MARCH 25, 2024

ADDENDUM NO. 1

TO CONSTRUCT **BIRKHIMER EMERGENCY OPERATIONS CENTER (EOC)
UPGRADES AND IMPROVEMENTS
PROJECT NO.: CA-202313-C
TAX MAP KEY: 3-1-042:600
Honolulu, Oahu, HAWAII**

7 STAIR DETAIL
CS501 NOT TO SCALE

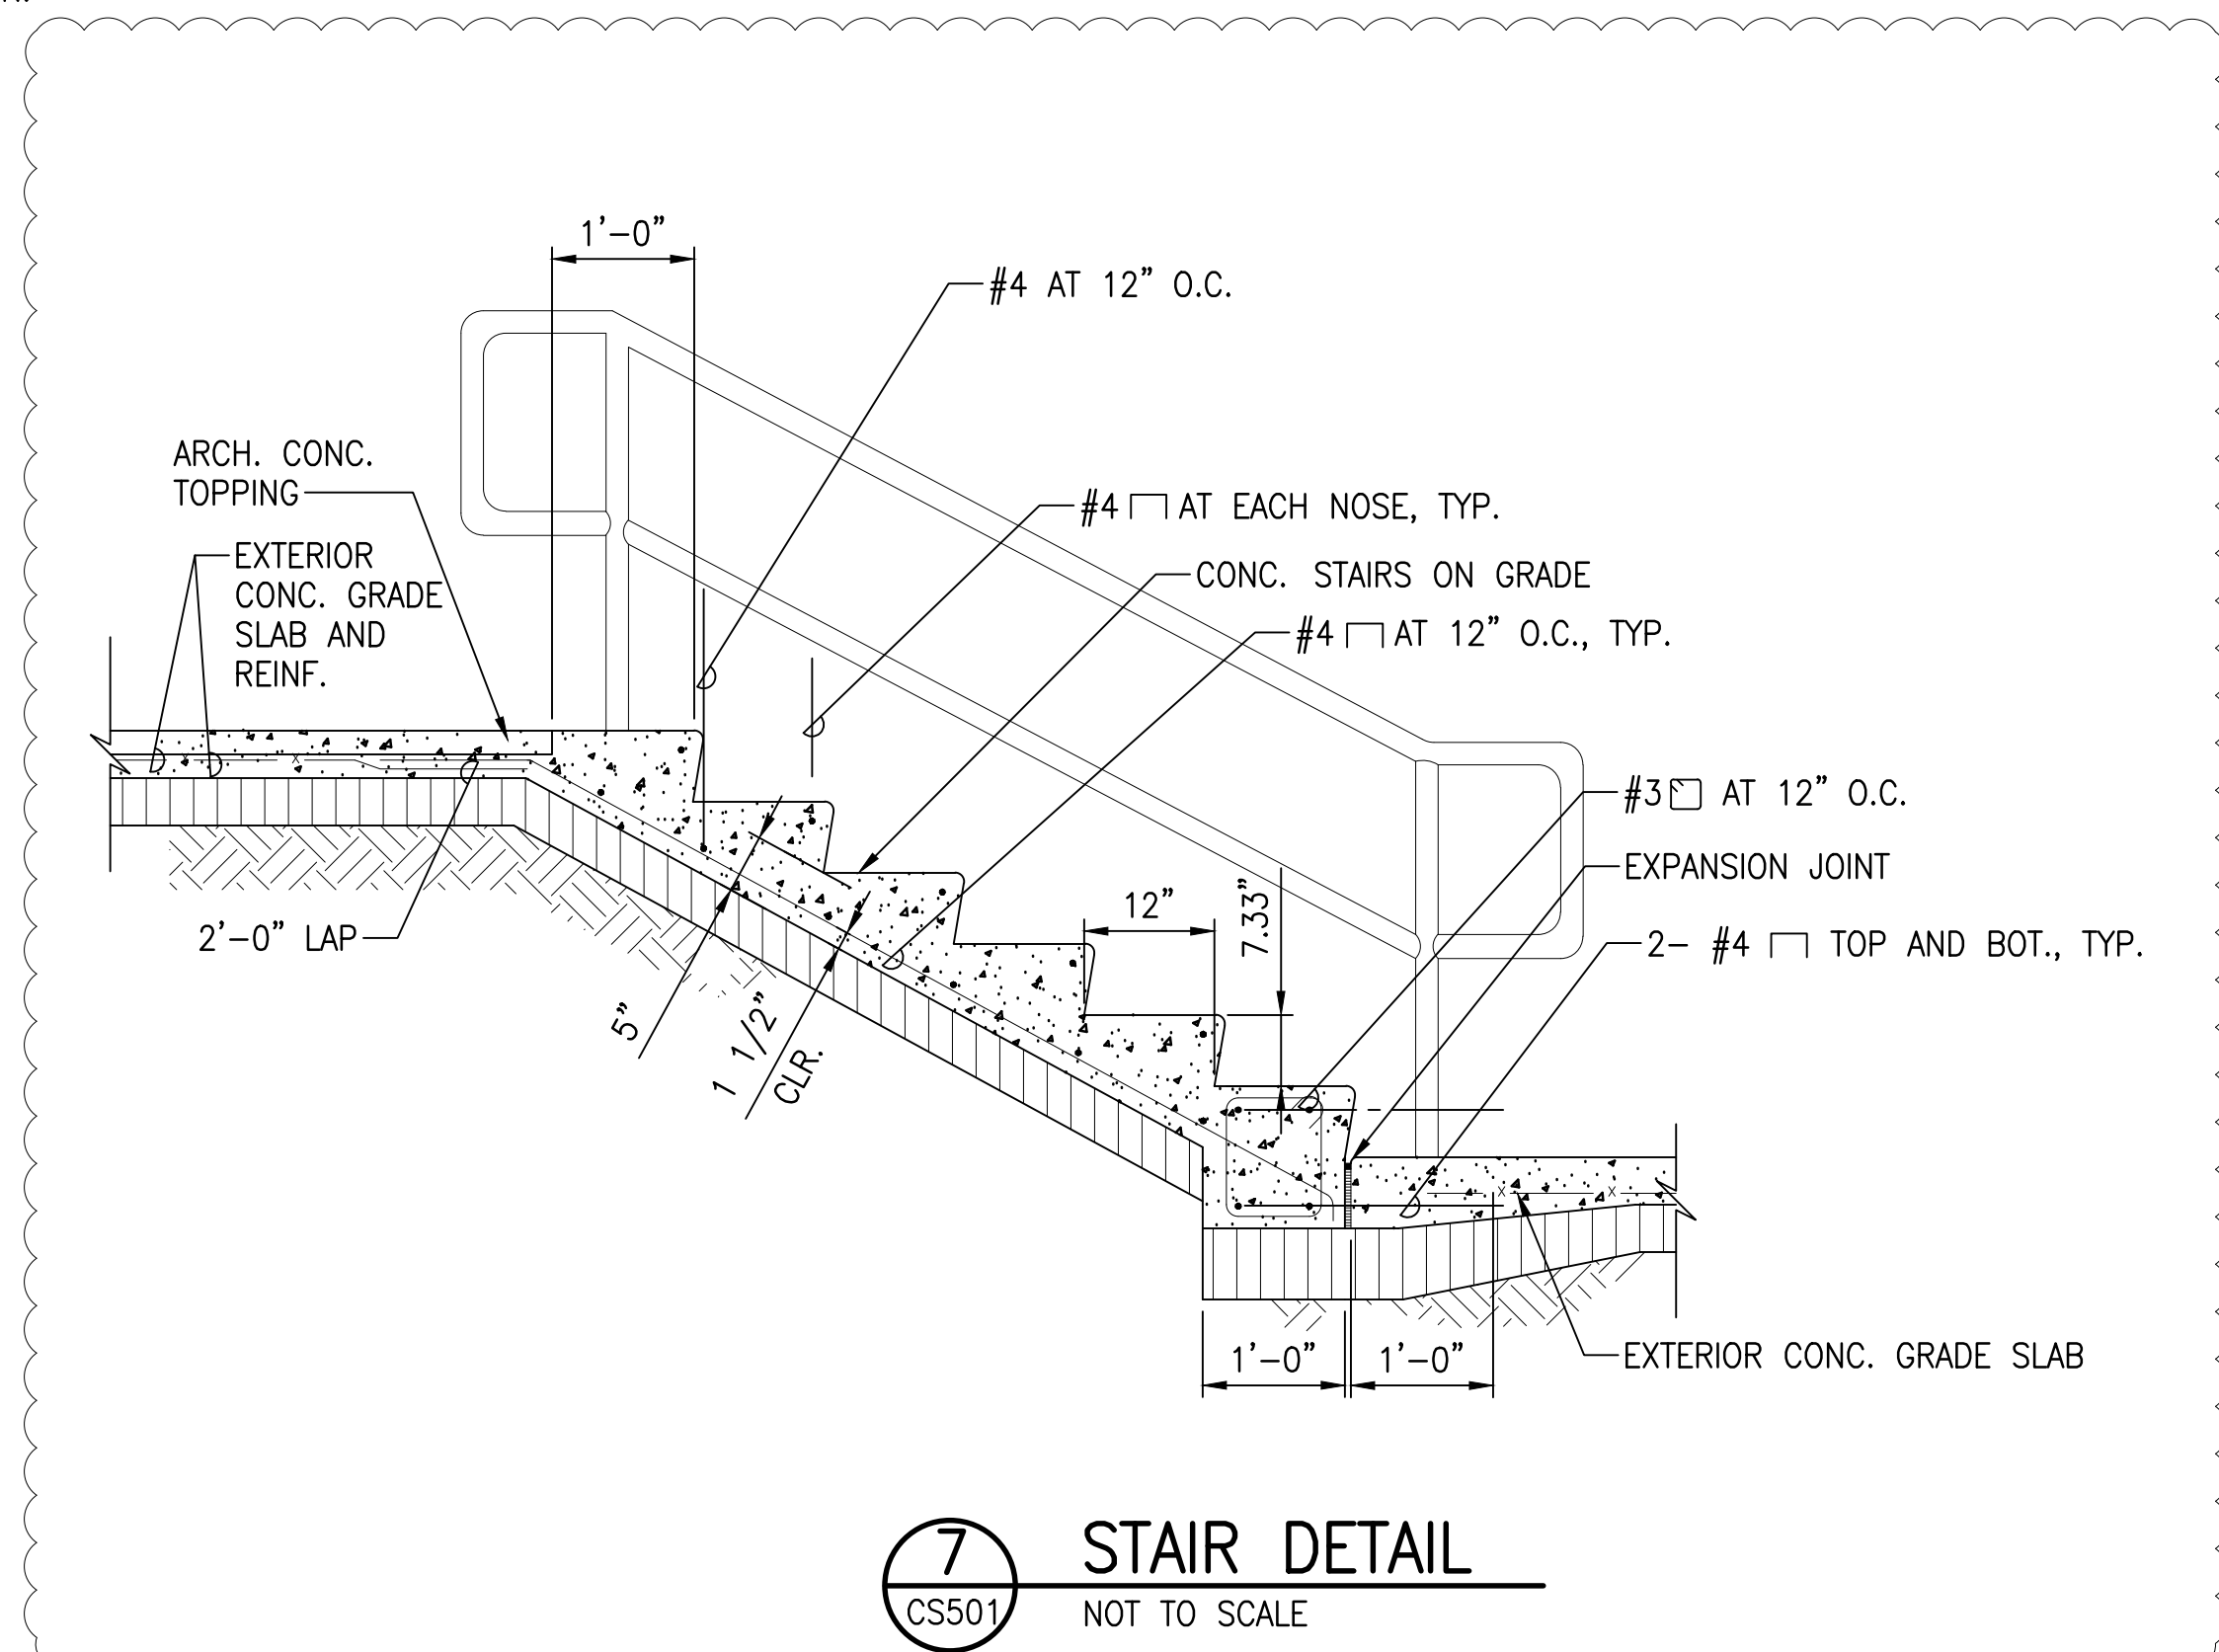
CIVIL	CS501	Add pavement structure detail Added wheel stop detail Added sign post detail Added stair detail
CIVIL	CS502	Revised gate detail to pedestrian gate
CIVIL	CG101	Revised tank location and retaining walls Elevate platform and added concrete steps
CIVIL	CG301	Revised platform elevation and retaining walls
CIVIL	CG302	Revised wall elevation
CIVIL	CP502	Revised paving limits
CIVIL	CU100	Shift fuel tank location north Revised 3" waterline alignment
CIVIL	CU100	Revised 3" waterline alignment Added backflow preventer on Waterline 1 Added backflow preventor on CWR line Added Detail A at water supply connection
CIVIL	CU202	Added drain line profile
CIVIL	CU203	Revised profiles
STRUCTURAL	S-101	Revised roof shoring note
STRUCTURAL	S-501	Revised repair notes
MECHANICAL	MB102	MECHANICAL ROOF PLANS Revised location of ACCU-2.
MECHANICAL	MB202	ENLARGED FLOOR PLAN AREA 2_5 – DEMO Revised note to temporarily remove the door frame for the closet serving AHU-2 during construction.

AS NOTED
CA-202313-C
FEDERAL PROJECT NO. -
SHEET 27 OF 123
AA101

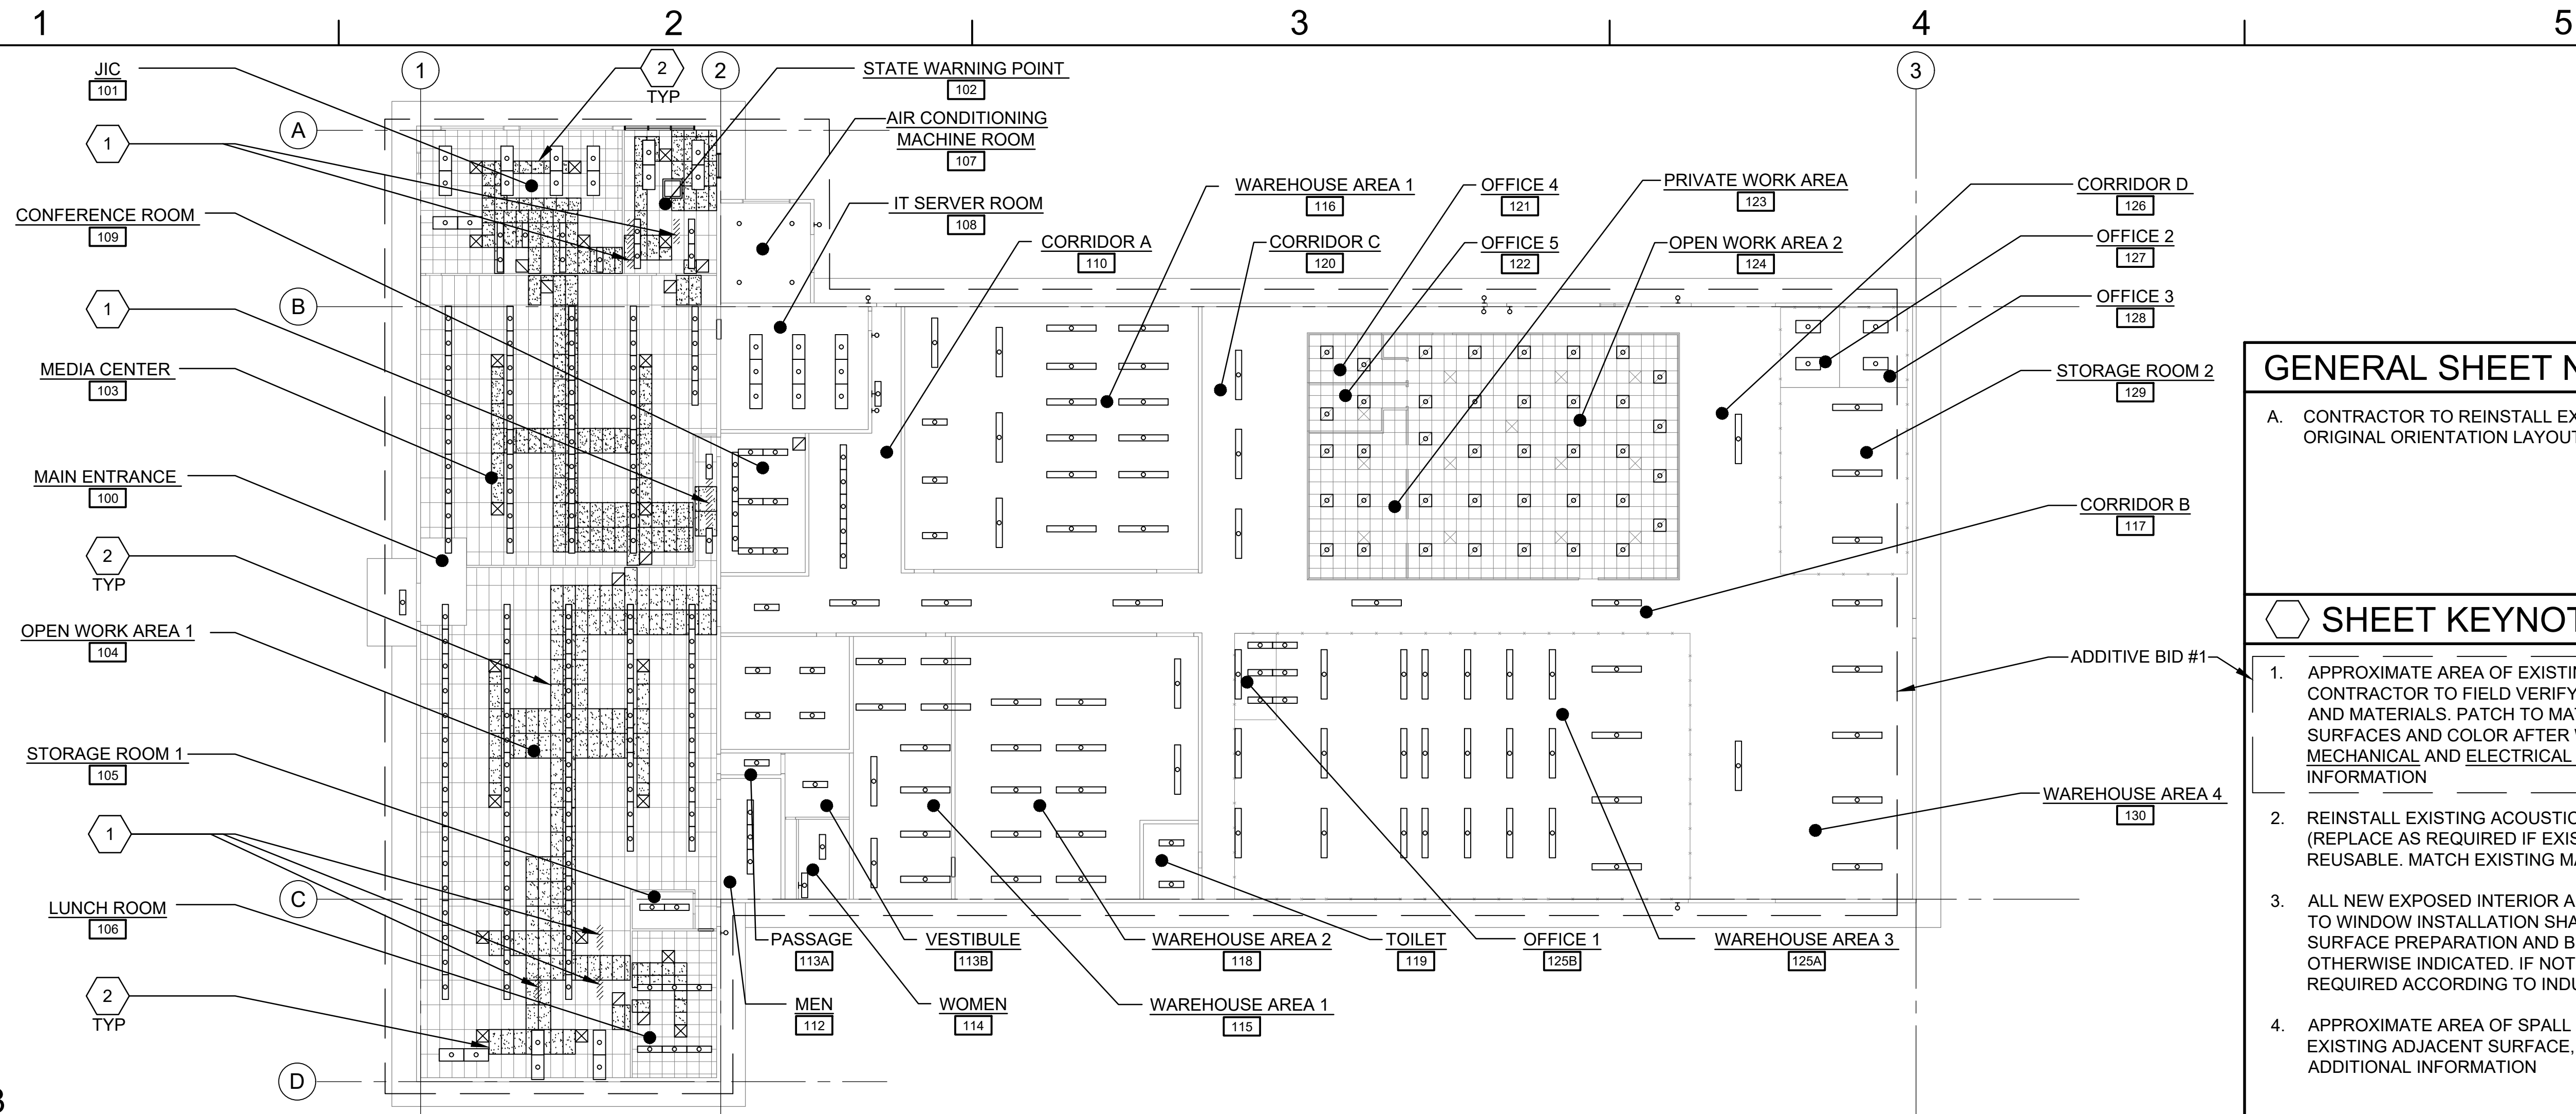
ARCHITECTURAL	AA101	<p>OVERALL FLOOR AND CEILING DEMO</p> <p>Revised demolition keynote to include “salvage and store existing window screen and associated frame for reinstallation.”</p>
ARCHITECTURAL	AA701	<p>SCHEDULE TYPES AND DETAILS</p> <ul style="list-style-type: none"> • Added “ASTM E 1996/1886 large missile impact (windborne debris)” to window schedule remarks. • Revised window detail graphics to represent new window • Revised existing frame graphics to more accurately represent existing condition • Revised window screen keynote to “Reinstall existing window screen, clips, and frame to match existing adjacent” • Revised window height in schedule.
ARCHITECTURAL	AB102	<p>OVERALL FLOOR PLAN AND CEILING</p> <p>Added note to temporarily remove door frame for AHU-2 installation.</p>
ARCHITECTURAL	AB103	<p>GENERATOR ROOM ROOF PLAN</p> <ul style="list-style-type: none"> • Relocated mechanical equipment off the roof, revised note to include support posts • Removed built out concrete pad and associated notes and dimensions
